Upgraded Plate Cylinder Shaft Bearing Retainer

for Stolle Concord Decorators

Stolle
Concord Decorator
Technical Update 1708-1

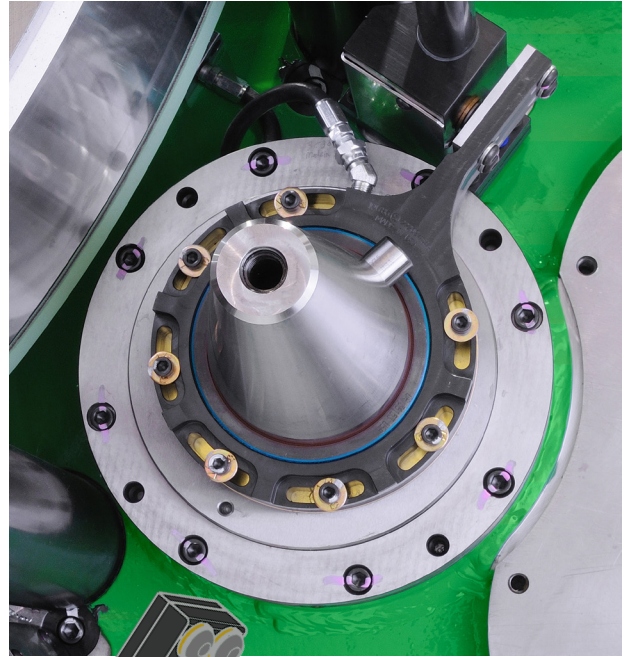
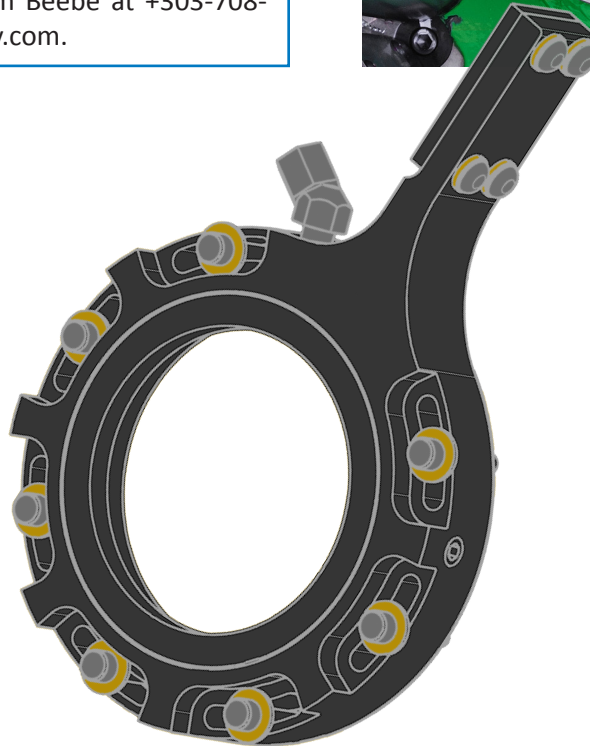
Stolle has upgraded the the plate cylinder shaft bearing retainer used on the Stolle Concord Decorator. This part was upgraded as the original retainer can slip. If the retainer slips when reducing plate pressure, the plate pressure will not change.

The bearing retainer has been upgraded with a wider machined surface to accomodate larger diameter hardened washers, and has a much stonger locking force to keep the retainer from rotating.

The upgraded plate cylinder retainer is standard on all new Concord Decorators, and it is available as a retrofit for all existing 8-color Concord Decorators (part number 222120980).
